# EclA Addendum and Outline Bat Sensitive Lighting Strategy

Land South of Ashford Road, Sellindge

June 2024

*This Technical Note has been prepared by CSA Environmental on behalf of Gladman Developments Ltd. in response to comments received from the Kent County Council (KCC) Ecological Advice Service (EAS)(dated 29.05.2024) in relation to proposals for residential-led development at 'Land South of Ashford Road, Sellindge' (Folkestone & Hythe District Council (FHDC) Planning Application Reference: 20/0604/FH), hereafter referred to as 'the Site'. Ecological information submitted to date alongside the application has been in relation to habitats, bat activity, breeding birds and reptiles. A desk-based assessment was made for great crested newts and a subsequent application for a District Level Licence (DLL) was made. KCC EAS comments have been provided in relation to these submitted documents. This Technical Note responds to those comments and updates the ecological impact assessment in response to design changes and additional survey information.*

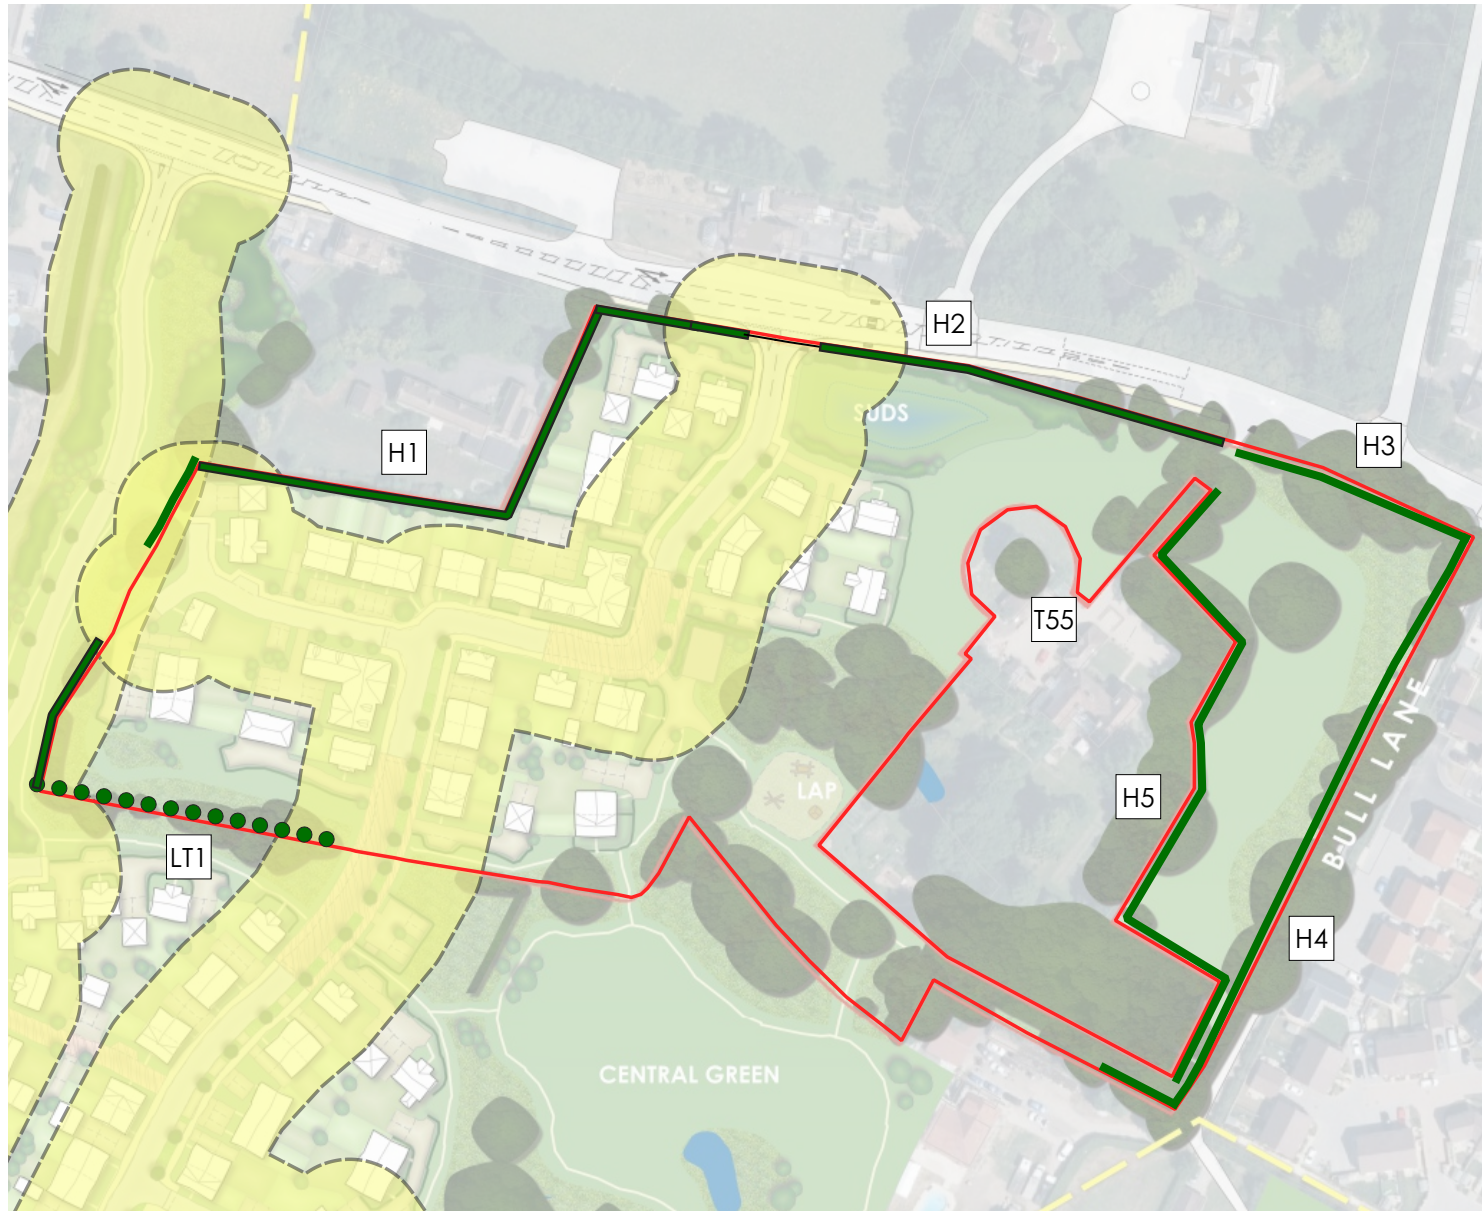
- 1.7 KCC EAS raised concern over the potential for bats to be roosting in trees also, referring to the latest bat survey guidelines (2023) that say where impacts to trees cannot be avoided a PRF inspection survey should be undertaken to record characteristics of the PRFs. The EAS then progress to say that because a lighting strategy considering both on-site and off-site lighting has not been provided, further survey of all potentially impacted trees for tree roosting bats should be undertaken in advance of determination.

- 1.10 This potential impact will also be limited in severity due to the extent of the development area and retention of preexisting foraging areas, as shown on the DFP (CSA/4509/122/E), which are known to be the areas on site most used by bats (See Figure 1 below, taken from the Bat Survey Report in the EclA CSA/4509/06/Rev C). It is also fair to acknowledge that no significant bat activity was recorded at the boundaries between application sites, indicating that this area does not constitute an important flight path for bats. As such, the above request for further surveys triggered by 'unavoidable impacts', is not considered reasonable or proportionate at this stage.
